Product Change Notice

Issue Date: 20-January-2022

New dice replacement for PCB base Seven Segment Display and Custom Module

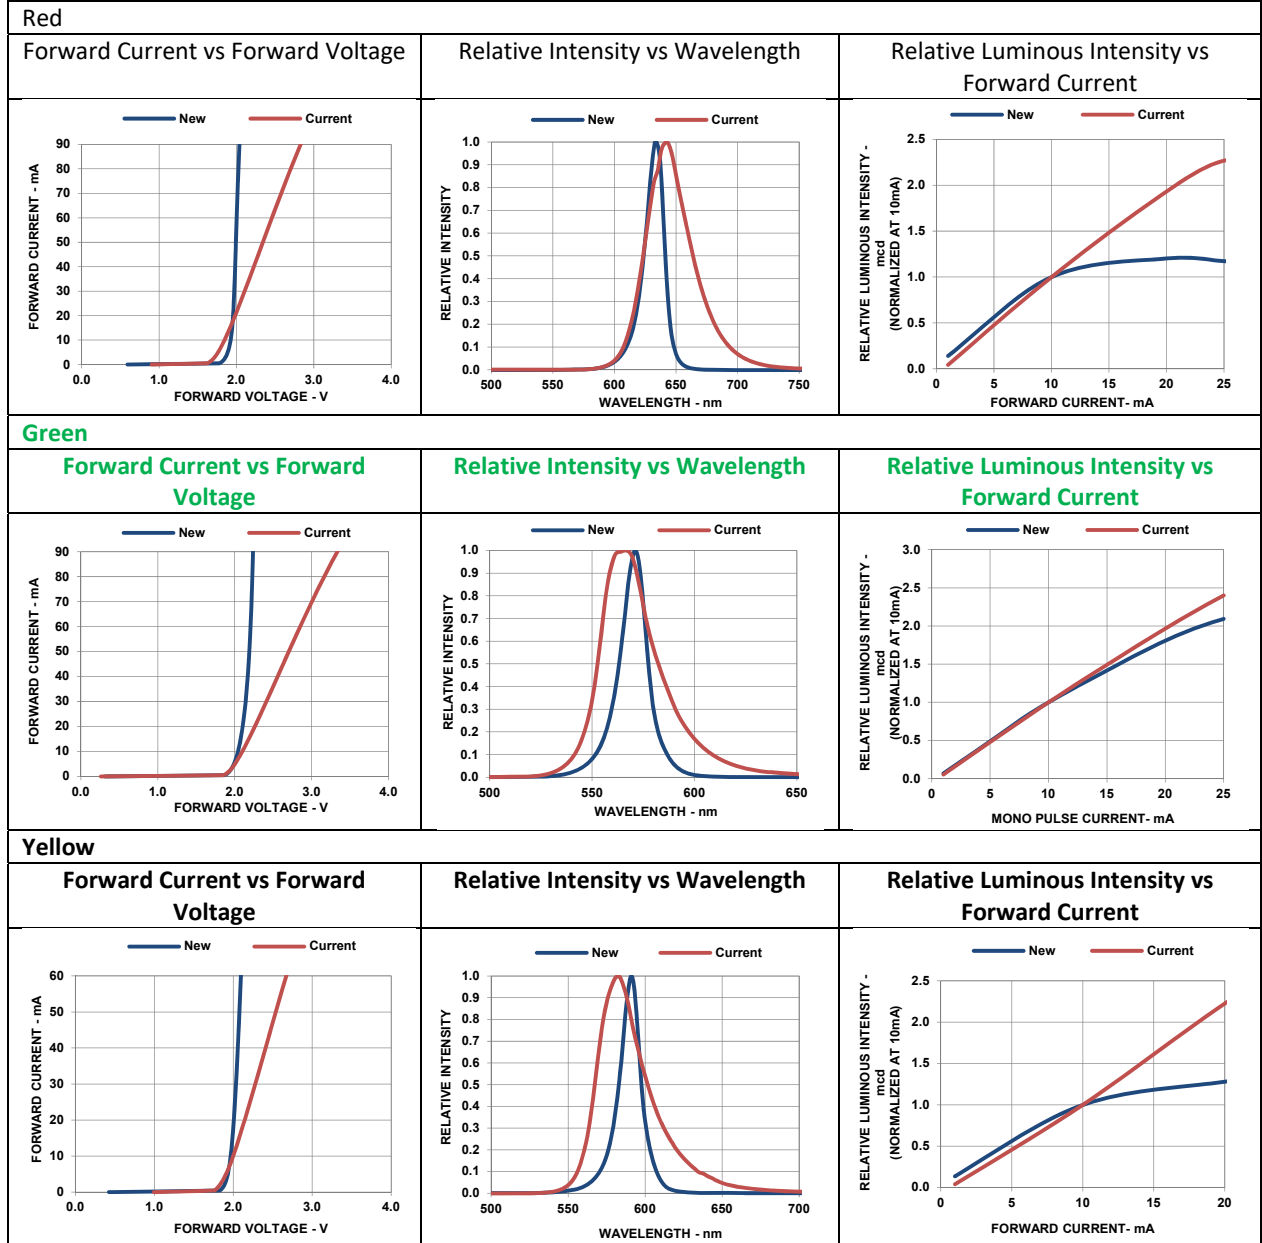
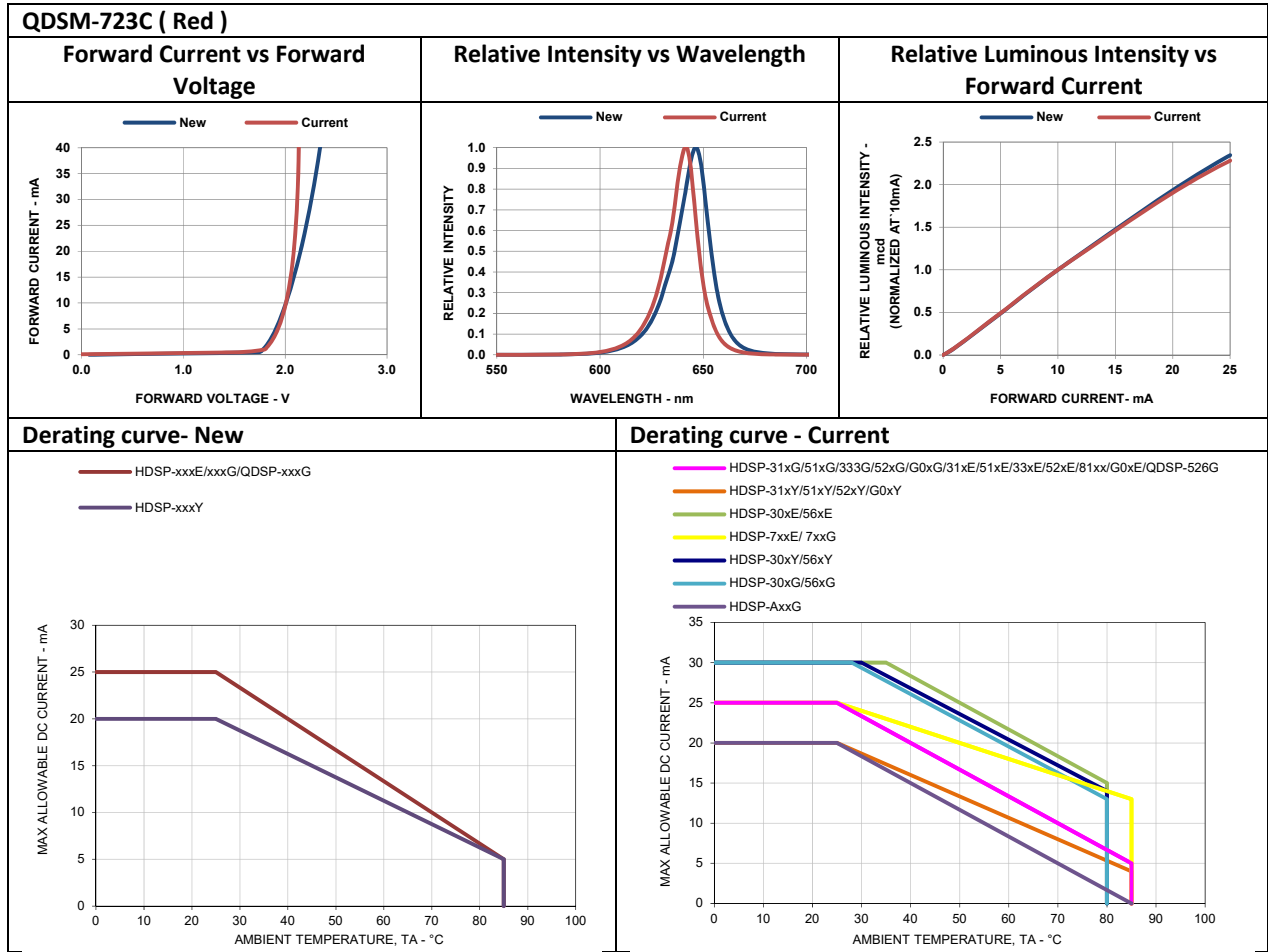
Following are changes in product characteristic:

1. Forward Voltage vs Forward Current
2. Relative Intensity vs Wavelength
3. Relative Intensity vs Forward Current
4. Storage temperature & operating temperature range will be standardized to -40°C/85°C
5. Power dissipation
6. Peak forward current
7. DC forward current
8. 1 to 3 Iv bin higher with new die source

Below are the comparison of the Electrical / Optical characteristic between the current & new dice:
